R03HC

Davenport Seat Belt Anchorage

MODELS AFFECTED: 2004 Blue Bird All American Rear Engines (A3RE) with Seat Belts

RECALL CAMPAIGN RO3HC

Figure 1

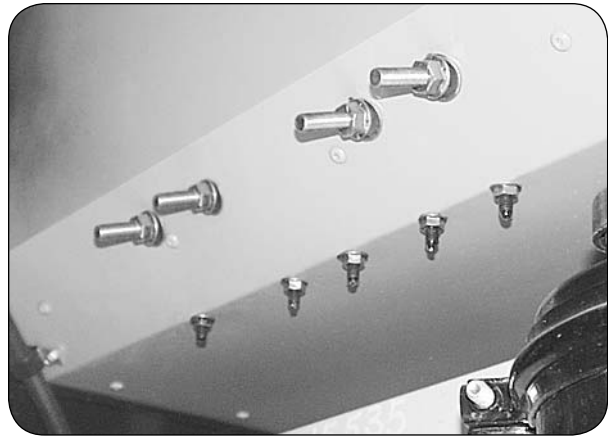
- 1** Park the bus on a level surface and apply the parking brake. Remove the key and chock the wheels. Disconnect the battery cables.
- 2** Open the engine compartment, allow the engine ample time to cool to ambient temperature.
- 3** Inspect the seat belt anchorage bolts protruding from the rear davenport wall. If the fasteners appear as shown in Figures 1 or 2 **STOP**. These installations are acceptable.

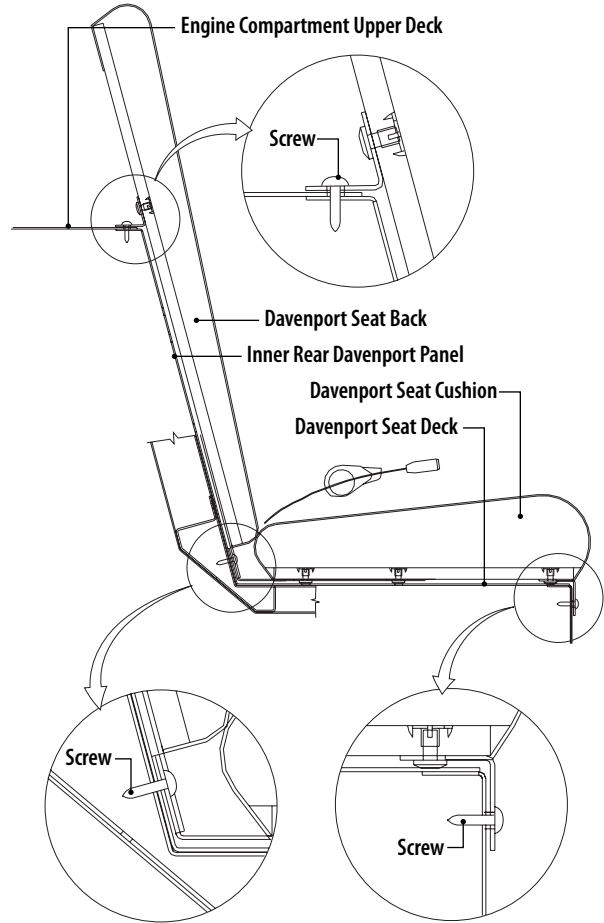
6 Using the hole pattern diagram that coincides with your seat size, drill 15/32 inch (.468) diameter holes through the rear davenport panel 7/8 inch (.88) above davenport seat deck. Maintain the drill at a 90 degree angle to the rear davenport seat panel. See "Hole Pattern Diagram" on page 3.

Steps Four Through Six

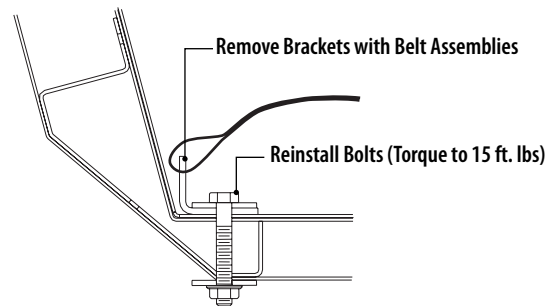
4 Remove screws that secure both davenport seat backs to the rear engine compartment upper deck. Lift and remove the seat backs.

5 Compress the rear of the davenport seat cushion and remove the screws that secure the seat cushions to the inner rear davenport panel.

6 Remove screws that secure the front edge of the davenport seat cushions. Lift and remove the seat cushions.

Steps Seven & Eight

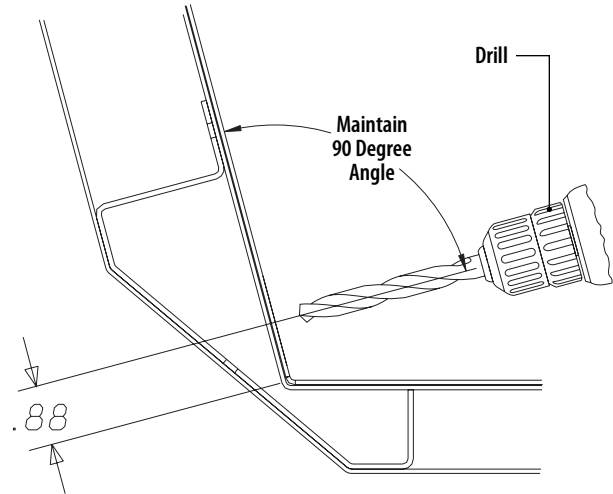
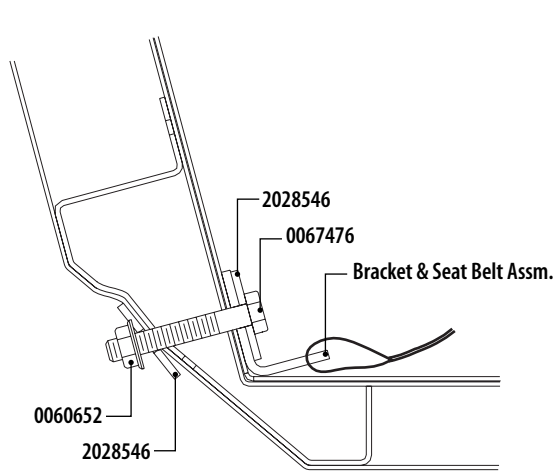
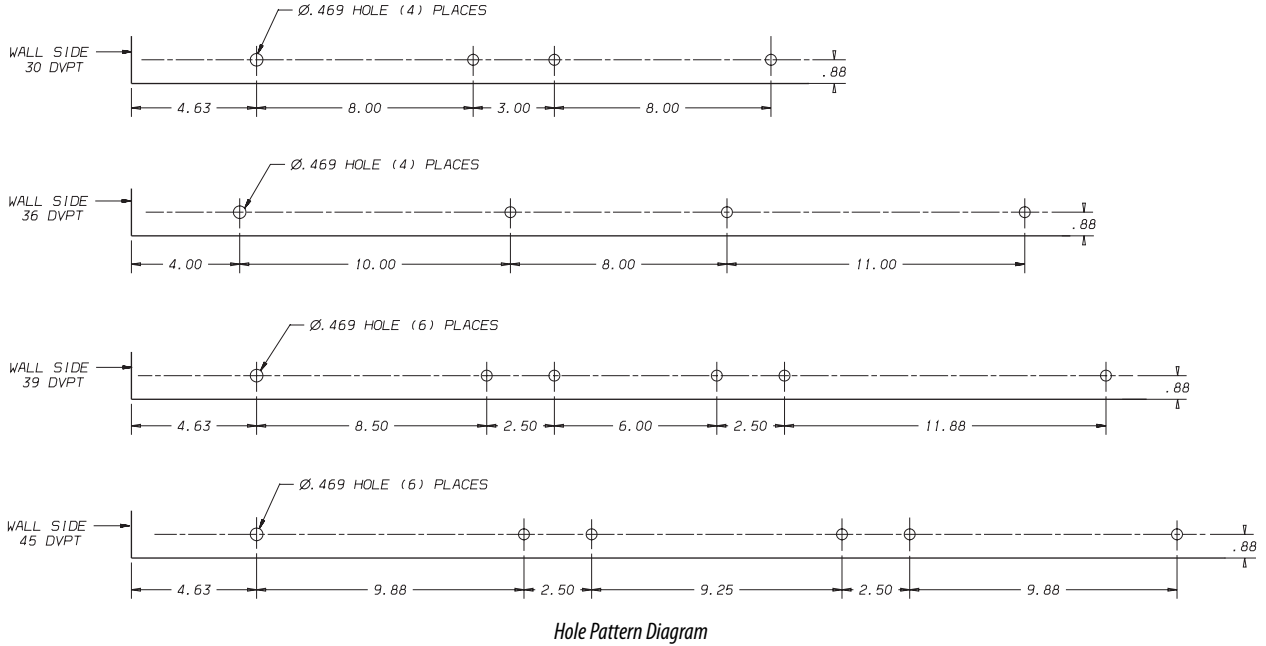
7 Inspect the bracket and seat belt assemblies, if damage to the bracket exist, please contact Bill Coleman at Blue Bird Body Company; Phone 478.822.2242.

8 Install bracket with seat belt in new position as shown in "Seat Belt Bracket Installation" on page 3. Install new 7/16 - 20 x 2.25 inch bolt (BB #0067476), two flat washers (BB #2028546) and flanged nut (BB #0060652). Bolts must be torqued to 30-33 ft. lbs.

Note: When torquing bolts during installation, panel compression may occur along the top edge of the nut and washer. At the same time, a gap may be noticed at the lower edge of the nut and/or washer. This condition is acceptable.
